FTI-FDK2: Vehicle Coverage and Preparation Notes

Overview: The initial production release of the FTI-FDK2 harness did not account for the use of aftermarket RF components and does not supply the connection that programs the module for aftermarket RF use. This issue affect the initial release and is currently being addressed in production, but for installations using aftermarket RF a field repair is provided below.

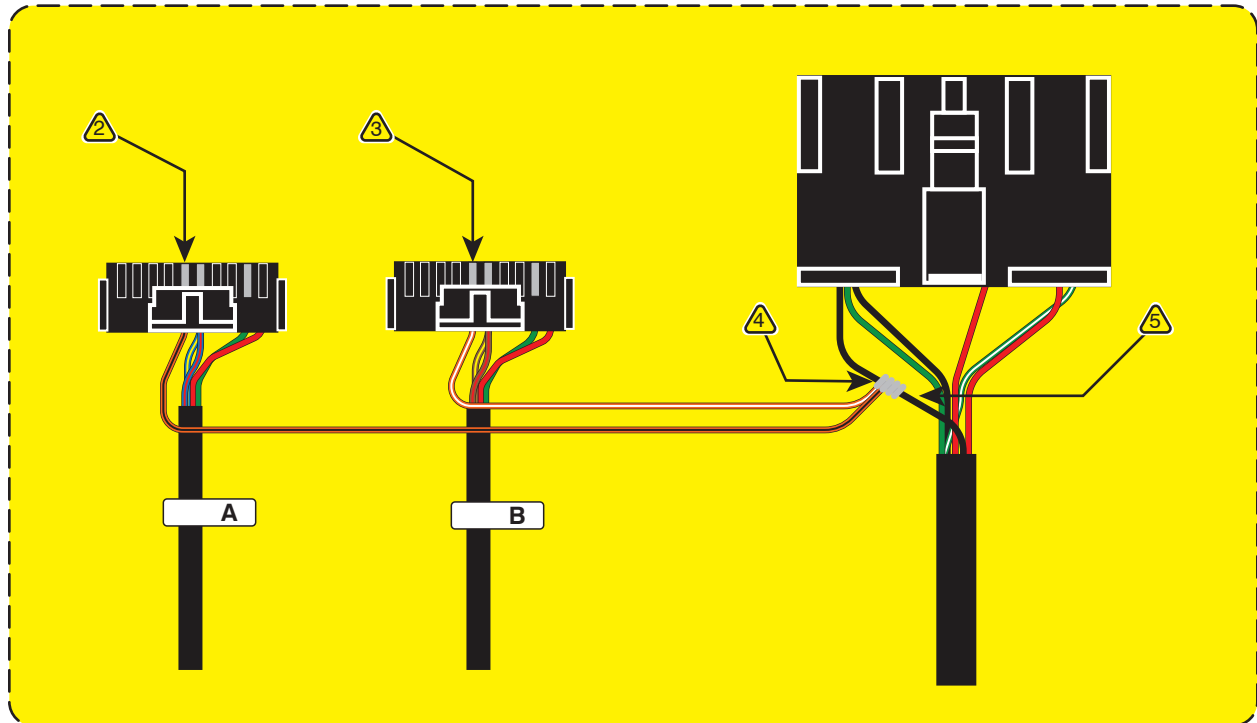
Issue: The orange black wire is not included in the BLADE connector. This wire must be present throughout steps 1 & 2 of the module programming procedure in order for the module to properly control the vehicle's door locks via aftermarket RF. The required wires can be sourced from the harness originally supplied with the BLADE cartridge, inserted into position #5 of each BLADE connector, and attached to either of the black ground wires in the CN1 connector of the harness.

Correction:

- 1.) Use a pick tool to depress the locking tab on the terminal connector of the orange/black & orange/white wires in pin positions #5 & #15 of the BLADE connector that was supplied with the BLADE module, remove wires for relocation.
- 2.) With locking tab repositioned, insert orange/black wire into position #15 of the connector marked [A].
- 3.) With locking tab repositioned, insert orange/white wire into position #15 of the connector marked [B].
- 4.) Extend the orange/black & orange/white wires to the CN1 connector, strip ends and attach to one of the black ground wires.
- 5.) Once the wires have been securely connected and insulated, you may proceed with module programming.
